NOTICE

6.1 MDA-2025/83 - 171 Bay Street, Botany - Section 4.55 Modification2

6.2 MDA-2025/23 - 95 Mimosa Street, Bexley - Section 4.55 Modification..23

Item No	6.1
Application No	MDA-2025/83
Property	171 Bay Street, Botany
Application Type	Section 4.55 Modification
Proposal	Modification to DA-2023/86 to delete condition 19a requiring retention of 2 eastern elevation ground floor windows
Owner	Mr M McCarthy
Applicant	Mr M McCarthy
Ward	Ward 1
Lodgement Date	20/05/2025
No. of Submissions	Nil
Cost of Development	\$0.00
Reason Criteria	Other
Report by	Peter Barber, Director City Futures

Figure 1: Approved Eastern Side Elevation

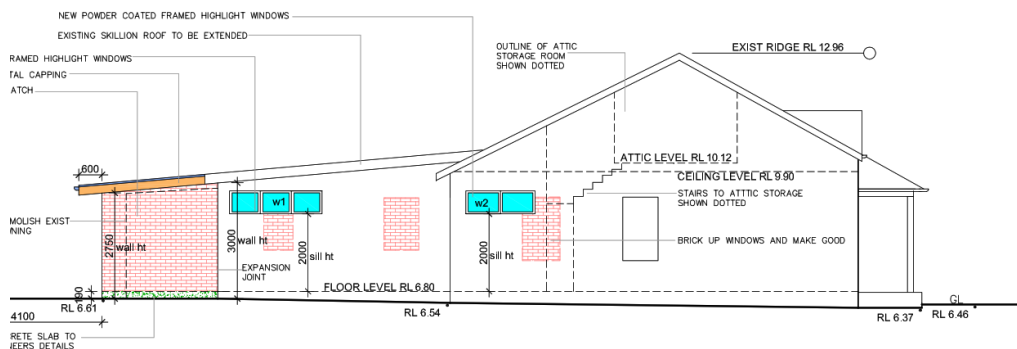
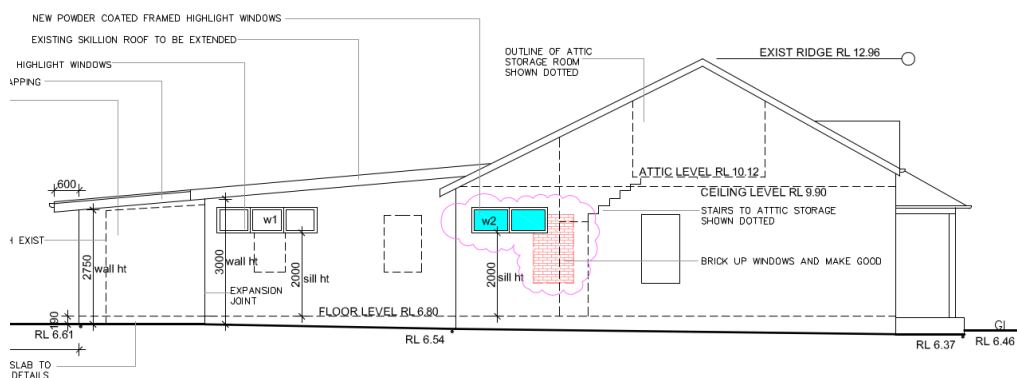
The proposed modification is not supported as it adversely impacts the heritage significance of the property at 171 Bay Street, which is listed in Schedule 5 of the Bayside Local Environmental Plan 2021. The bricking up of the existing window below the attic stairs is not adequately justified and would result in the loss of original architectural features. The application of a translucent privacy film to the existing bathroom window (as per the applicants SEE) is an acceptable reversible measure that preserves the heritage items value.

The application seeks consent to modify the approved development at 171 Bay Street, Botany by deleting condition 19a requiring retention of the two northernmost windows on the eastern elevation of the ground floor. The applicant sought to remove the existing lounge room window and proposed a highlight bathroom window. This condition to retain the existing window was

The section (drawing number 2/23A) from the approved Development Application (DA) plans indicates that the first existing window, previously not identified for bricking up, is situated below the attic stairs. Without additional supporting documentation, the necessity of removing this window for the construction of the stairs is not adequately demonstrated. Consequently, the bricking up of this window is not supported on heritage grounds.

Figure 1 – Approved Site Plan (DA-2021/488). (Note - Recessed spaces are circled in red)

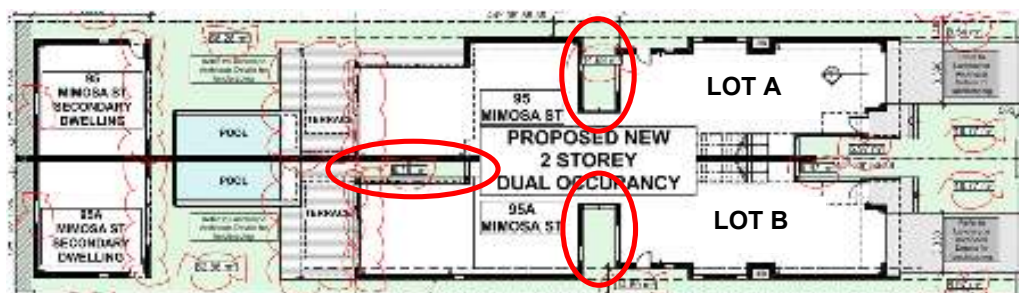
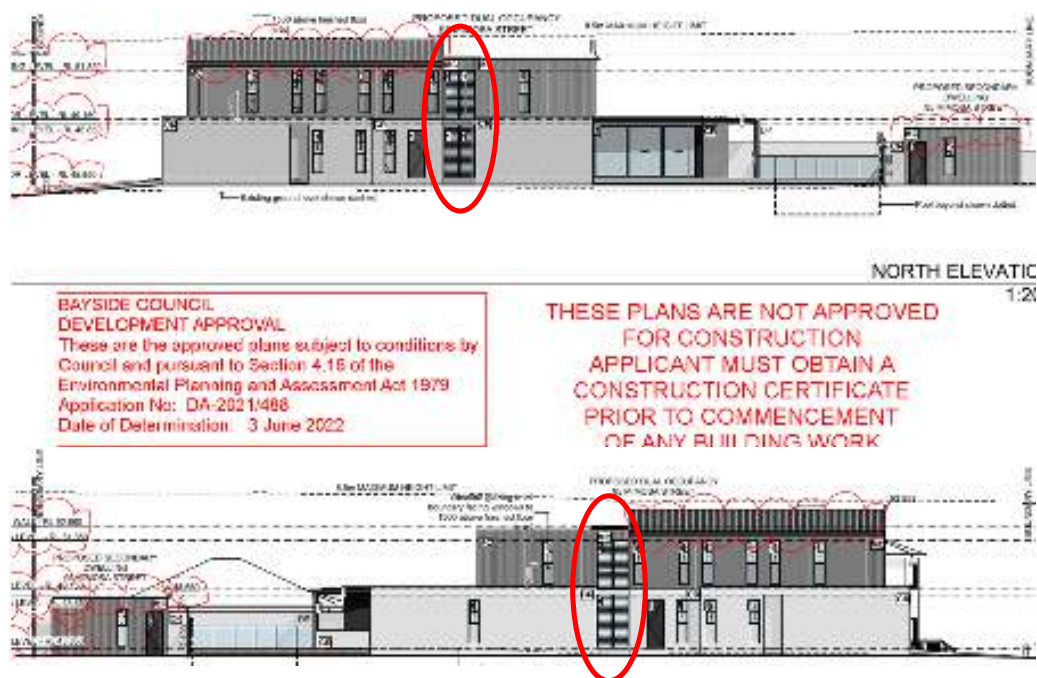
The plans below show the recessed areas that have now been enclosed.

Figure 3 – Approved Floor Plan (MDA-2024/113). Redacted.

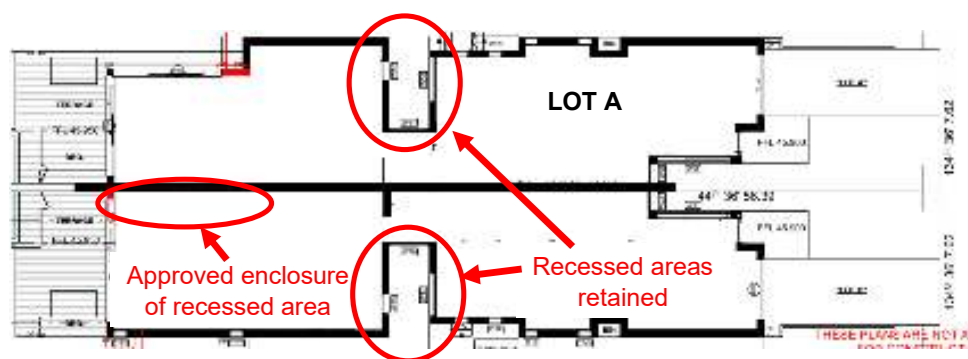
This modification application approved the enclosure of the recessed area to the rear of the southern dwelling (Lot B) - see **Figure 3** below.

The applicant originally sought to enclose both recessed areas to the sides, however Council officers were not supportive and the applicant deleted this from the proposal.

Figure 4 – DA-2025/23 – Proposed Ground Floor Plan (redacted)

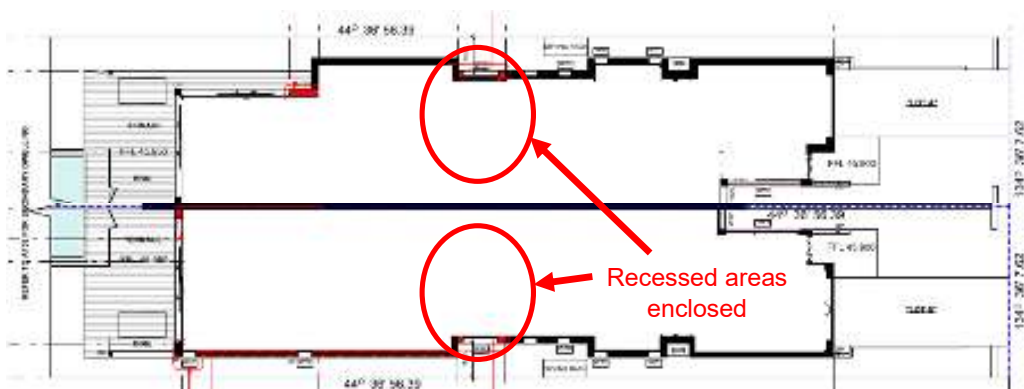
- Recessed spaces have been enclosed and result in an exceedance of maximum floor space ratio pursuant to clause 4.4(2E) of Bayside Local Environmental Plan 2021. The variation exceeds 10% and must be referred to the Bayside Local Planning Panel for determination.
- A variation to clause 4.4(2E) is only permitted subject to a demonstrable public benefit. A negotiated outcome has resulted in a condition requiring payment to Council to facilitate planting of forty street trees in Mimosa Street.

Both recessed areas to side elevations were enclosed without prior approval. This modification application seeks approval for the use of these enclosed areas - see **Figure 4**.

Figure 5. Shadow diagrams provided for DA-2021/488 for 9am to noon. The void is visible in the proposed shadow diagram, which can be used as a guide on the potential overshadowing impact of the infill.

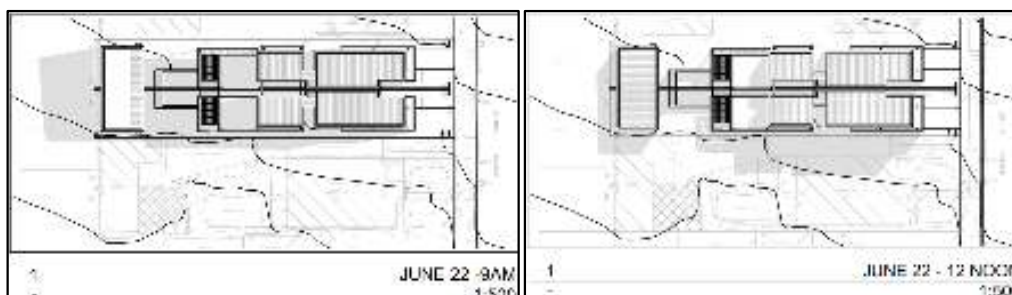
Shadow diagrams have not been provided in this application, however previous shadow diagrams have been provided for the Development Application DA-2021/488 which can be used as a guide on the potential impacts. The proposal does not result in any real change to the solar amenity of the proposed / approved development. With regards to impacts to neighbours, the changes will be minimal. Figure 5 shows that the private open space of the neighbouring (southern) property is not significantly impacted for 3 hours between 9am and midday, and that impacts windows located within the dwelling on the southern lot will have minimal change due to the size of the enclosed slot and the larger setback of the dwelling beyond the existing driveway which runs along the northern side of the southern neighbours site. As a result, requiring shadow diagrams to be provided is considered to be too onerous in this circumstance.

Given the above assessment regarding the solar access and overshadowing objectives and controls, it is reasonable to conclude the proposal is acceptable in this instance.
